UNITED STATES PATENT AND TRADEMARK OFFICE

10/567,480

Office Action Summary	Application No. 10/567,480	Applicant(s) SCHLOESSER ET AL.	
	Examiner VICTORIA HICKS	Art Unit 3772

DETAILED ACTION

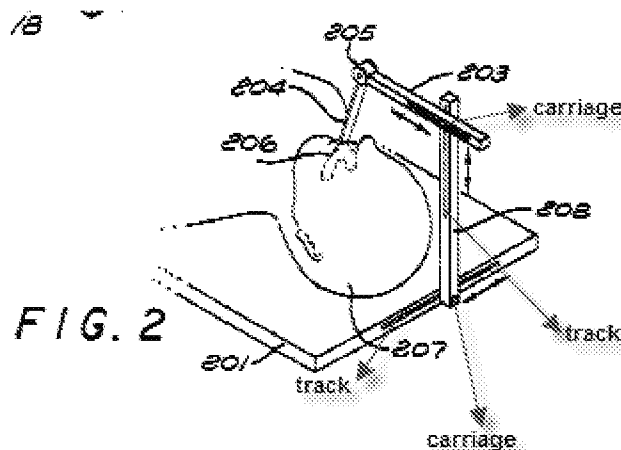
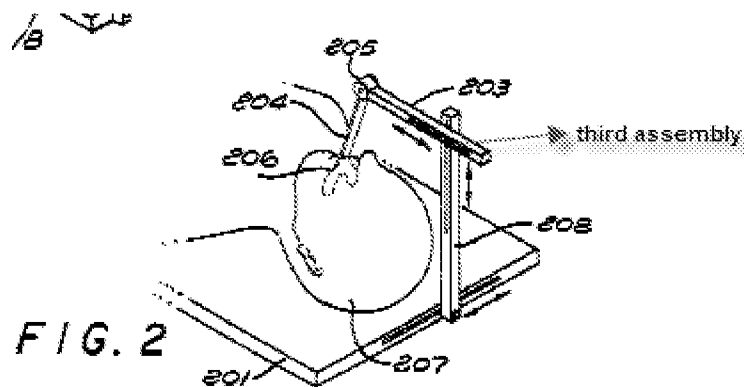
In regards to claim 7, Cosman teaches the apparatus of claim 2. Cosman teaches in Figure 2 and column 3, lines 37-47 that the first assembly comprises a track and a carriage connected to the frame (203, 204, 205), the carriage adapted to move along the track (see annotated copy of Figure 2 below).

In regards to claim 9, Cosman teaches the apparatus of claim 2. Cosman teaches in Figure 2 and column 3, lines 37-47 that the second assembly comprises a track and a carriage adapted to move along the track (see annotated copy of Figure 2 above).
